## PRODUCT CHANGE NOTIFICATION

Date: May 3, 2021  
PCN: PCN LEDIL 171

Subject: PCN 171 - Correction of product mechanical drawing

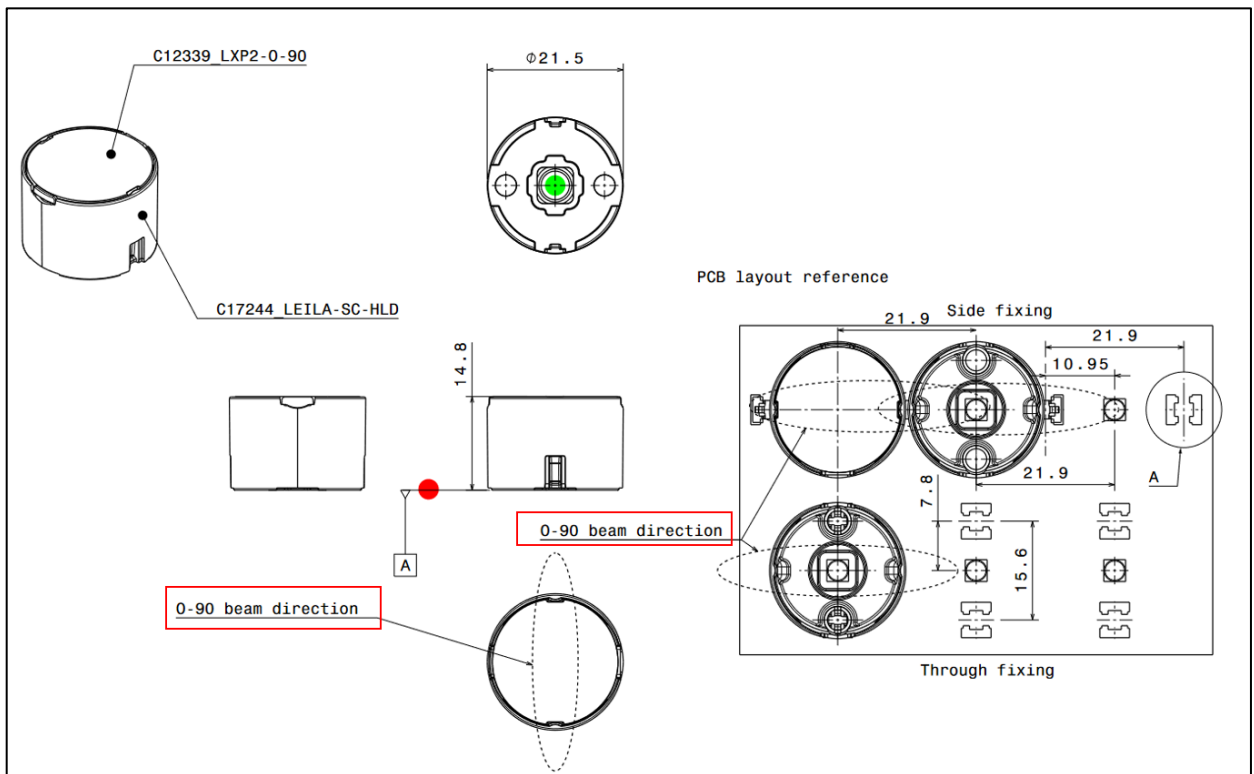
Description: As part of our continuous improvement process regarding the quality of our products, LEDiL has corrected incorrect information on the mechanical drawing of CP17590\_LEILA-SC-O-90. Light distribution orientation indicator mark has now been updated in the right direction.

Changes: CP17590\_LEILA-SC-O-90 mechanical drawing update.  
Updated light distribution direction mark orientation.
